Access Compliance Report Public Rights-of-Way (Curb Ramps)

Intersection ID: 20432 Main Street: SILVER_SPUR_CT Cross Street: STEELECHASE_DR Location: NW

ADA ID: 543966A44F8A Ramp Type: PerpDiag Initial Pass/Fail: Fail Overall Compliance: No Severity Score: 12.5

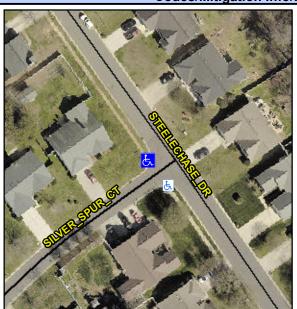
Not Found, R304.2.2

Field Measurements/Component Compliance					
Compliance Description		Data	Comp	liance Description	Data
N/A	Ramp Length (in)	48.0	No	Ramp Slope (%)	10.7
Yes	Ramp Width (in)	48.0	Yes	Ramp XSlope (%)	1.5
N/A	Flare Type LT	N/A	N/A	Flare Type RT	N/A
N/A	Flare Slope LT (%)	N/A	N/A	Flare Slope RT (%)	N/A
N/A	Flare Traversable LT?	N/A	N/A	Flare Traversable RT?	N/A
N/A	Landing Length (in)	N/A	N/A	DWS Provided?	N/A
N/A	Landing Width (in)	N/A	N/A	DWS Contrast?	N/A
N/A	Landing Slope (%)	N/A	N/A	DWS Length (in)	N/A
N/A	Landing X Slope (%)	N/A	N/A	DWS Full Width?	N/A
N/A	Landing Curb? (Y/N)	N/A	N/A	DWS Offset (in)	N/A
N/A	Shared Landing?	N/A			
N/A	Gutter Ponding?	N/A	N/A	Gutter Slope (%)	N/A
N/A	Gutter Lip Ht (in)	N/A	N/A	Gutter X Slope (%)	N/A
N/A	Painted X Walk1?	No	N/A	Painted X Walk2?	No
	X Walk 1 Direction	To SE		X Walk 2 Direction	To NE
N/A	X Walk 1 Width (in)	N/A	N/A	X Walk 2 Width (in)	N/A
	X Walk 1 Slope (%)	0.1		X Walk 2 Slope (%)	5.7

Remove & Replace Curb Ramp With Two New Directional Ramps or Equivalent.
